# Safety Evaluation Report

Related to the SHINE Medical Technologies, LLC  
Operating License Application for a Medical  
Radioisotope Production Facility

Docket No. 50-608

February 2023

Figure 2-1: Comparison of SSE (yellow) with uniform hazard spectra for SDC-3 and SDC-4 facilities using site-specific subsurface information

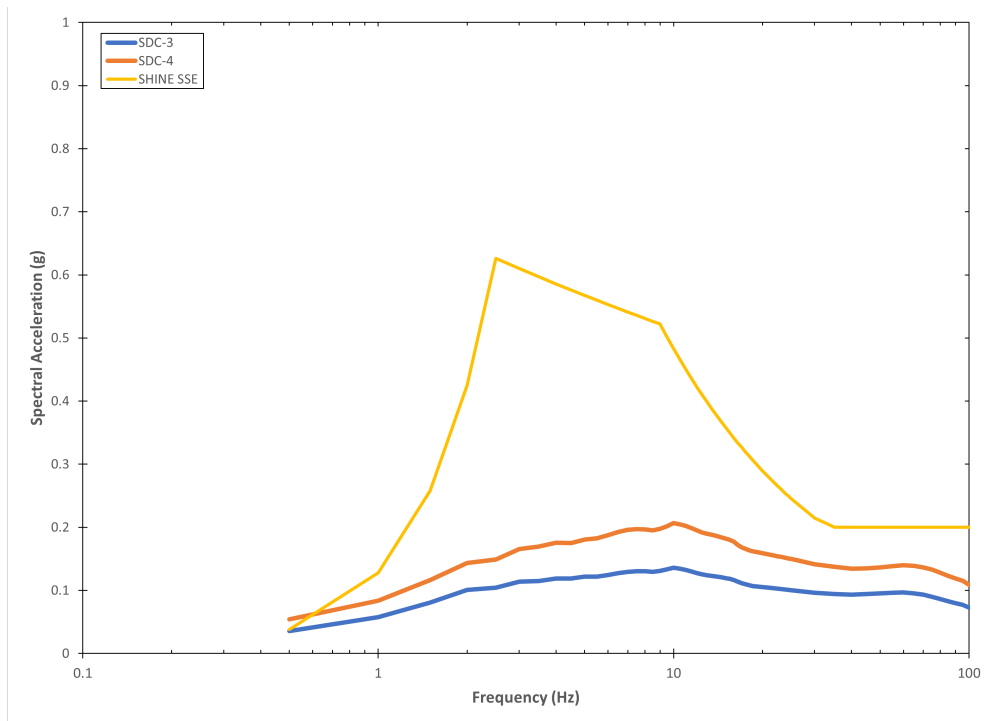
In addition to reviewing the application and the USGS results, the NRC staff performed a confirmatory PSHA that incorporates at-site information about the subsurface geology to develop uniform hazard spectra at the surface for Seismic Design Classification 3 and 4 (SDC-3 and SDC-4) facilities as defined in ANSI/ANS-2.26-2004, “Categorization of Nuclear Facility Structures, Systems, and Components for Seismic Design,” and computed following guidance in ASCE/SEI 43-05, “Seismic Design Criteria for Structures, Systems, and Components in Nuclear Facilities.” The staff used the seismic source model described in NUREG-2115, the ground motion model described in “EPRI (2004, 2006) Ground-Motion Model (GMM) Review Project,” 2013, and the site-specific dynamic properties described by the applicant in letter dated October 4, 2013 (ML13303A887), Enclosure 2 Attachment 26, “Preliminary Geotechnical Engineering Report (Janesville), Revision 3 (ML13309B618). The staff’s results, presented in figure 2.4.5-1, show that for an SDC-4 facility, the SSE envelopes the site-specific hazard at all frequencies greater than 0.6 hertz with significant margin. Greater margin is demonstrated for an SDC-3 facility.
